GIDHAUR-SIP-DNR

PANEL SIGNALLING PLAN
MACLS STD-~~III~~ II II Ⓡ III Ⓡ VIII CLASS-'B'

GIDHAUR

II ECR/SIP/DNR/121/ 2011
~~S.I. 07485/105~~

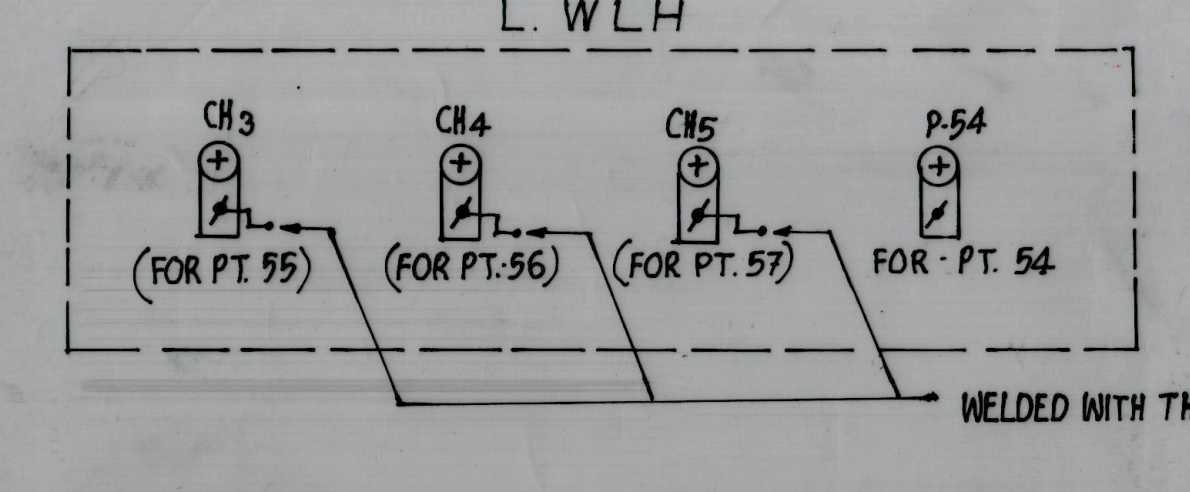
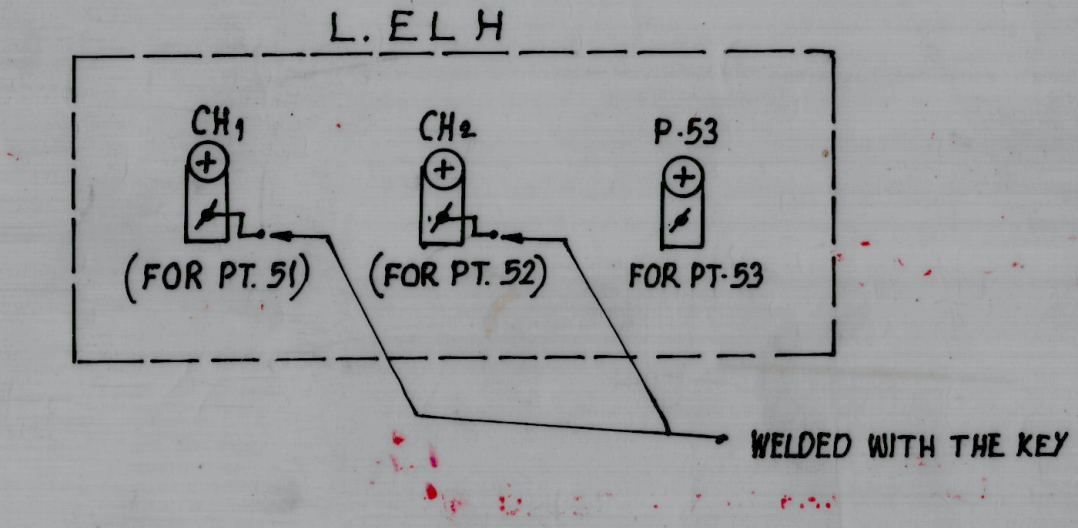
1. A. B. SYSTEM OF WORKING WITH DADPUR B.H. AND CHAURA B.H.
2. ~~DOUBLE LINE BLOCK INSTRUMENT SW/HWH TYPE WITH DADPUR B.H LOCATED AT PANEL CABIN AND DOUBLE LINE BLOCK INSTRUMENT WITH CHAURA B.H. LOCATED AT PANEL CABIN.~~ IV

3. CONTROL PHONE PROVIDED AT SM's OFFICE (PANEL CABIN) AND MAGNETO TELEPHONE CONNECTED BETWEEN L-WLH, SM's OFFICE (PANEL CABIN) ~~&~~, L-ELH. VI & L.C. GATE NO: 41/C/E

4. ~~AXLE COUNTER WORKS IN DADPUR-GIDHAUR IN UP DIRECTION & CHOURA-GIDHAUR IN DN. DIRECTION FOR L.V. VERIFICATION & INTERLOCKED WITH DLBI.~~ II & DN. UP & II

5. ~~3-POLE~~ LAMPS TO BE USED. II LED SIGNAL
6. ~~UP & DN. LOOP LINES ARE PROVIDED WITH AXLE COUNTER.~~ VII
7. ANGLE OF CROSSINGS ARE 1 IN 8½ EXCEPT OTHERWISE INDICATED.

8. UFSBI BLOCK PANEL WITH HASSDAC WORKING BETWEEN GHR-DPX. IV
9. UFSBI BLOCK PANEL WITH HASSDAC WORKING BETWEEN GHR-CUX.
10. TRACK CIRCUIT PROVIDED AS BERTHING TRACK IN BOTH UP & DN LOOP LINES IN LIEU OF ANALOG AXLE COUNTER. (UAC). VII
